ECE/TRANS/WP.29/1080
14 December 2009

Amendments to Annex 3 Part 7 of Regulation No. 48
(Installation of lighting and light-signalling devices)

Annex 3, Part 7, amend to read:

"PART 7 EXAMPLES TO ENABLE A DECISION REGARDING THE RECIPROCAL INCORPORATION OF TWO FUNCTIONS

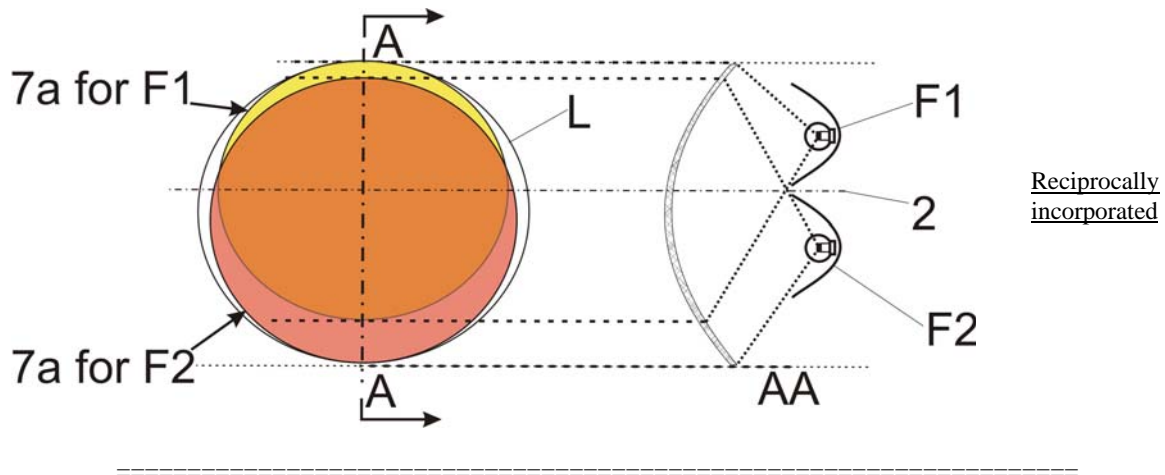
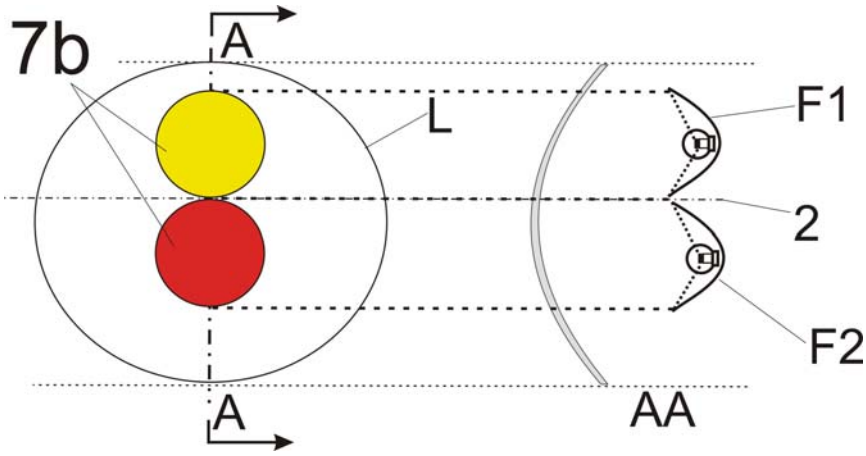
In the case with a textured outer lens and a wall in between:

In the case with a textured outer lens:

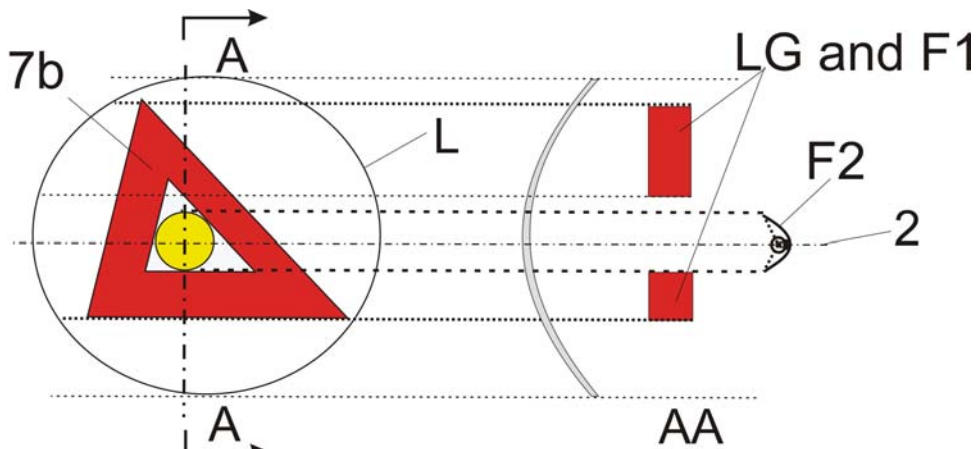
In the case where the non-textured outer lens is excluded:

Not reciprocally
incorporated

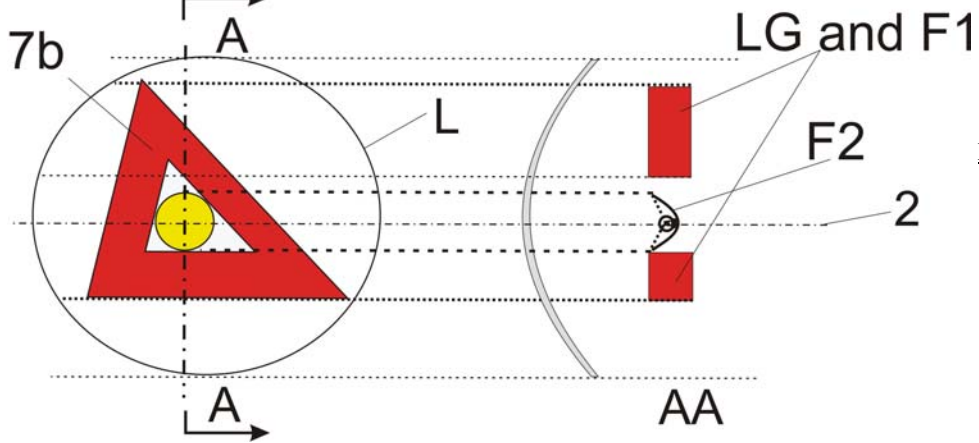
In the case where the non-textured outer lens is excluded:

Not reciprocally
incorporated

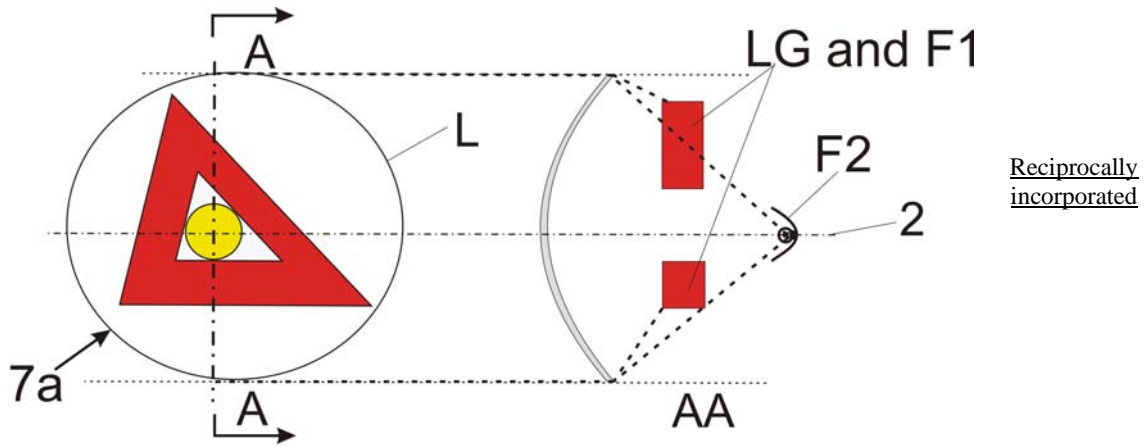
Not reciprocally
incorporated

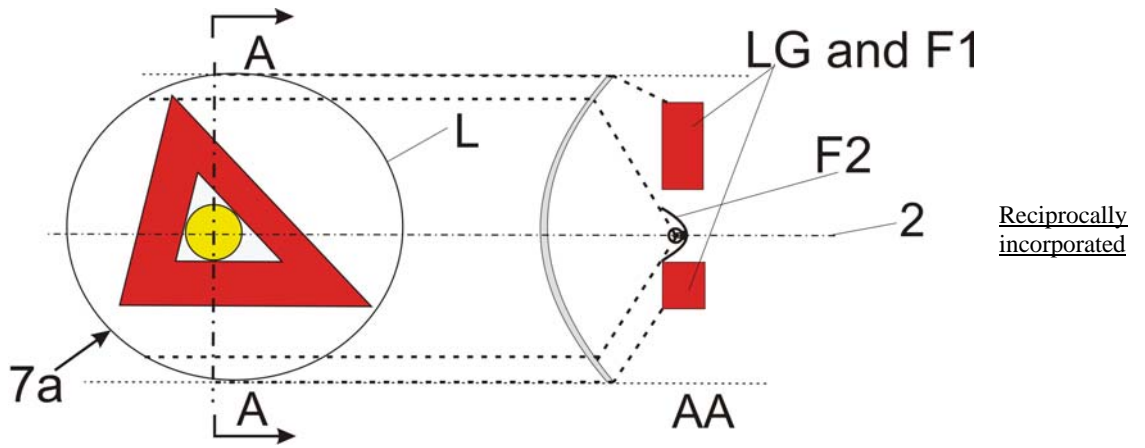
In the case where the outer lens (textured or not) is included:

Reciprocally
incorporated

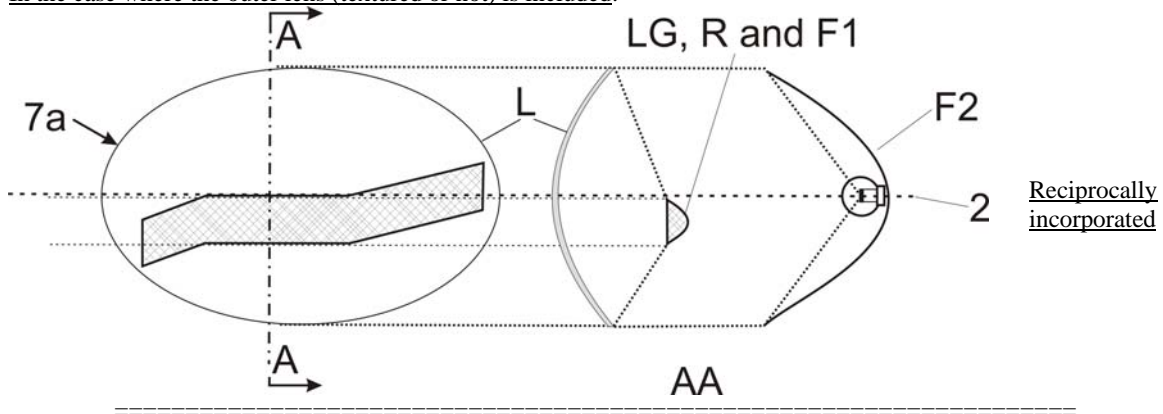
Reciprocally
incorporated

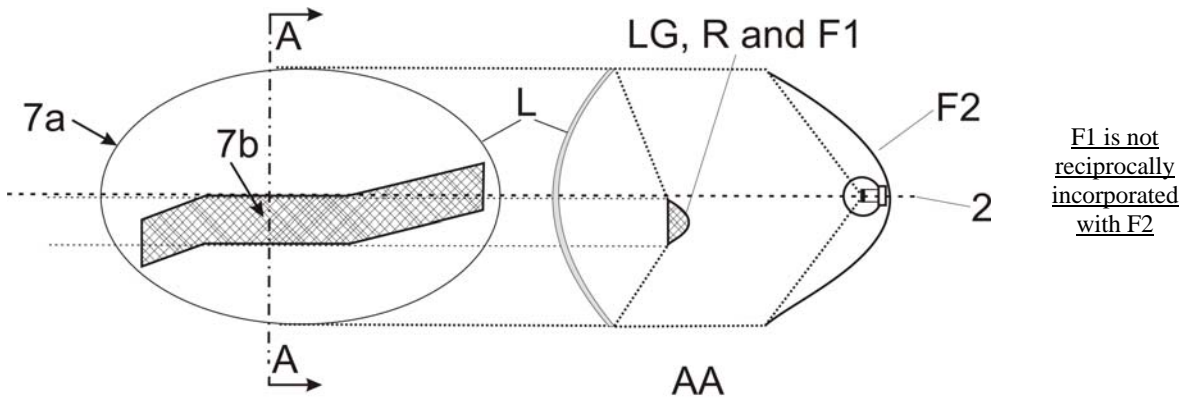
In the case where the outer lens (textured or not) is included:

Reciprocally
incorporated
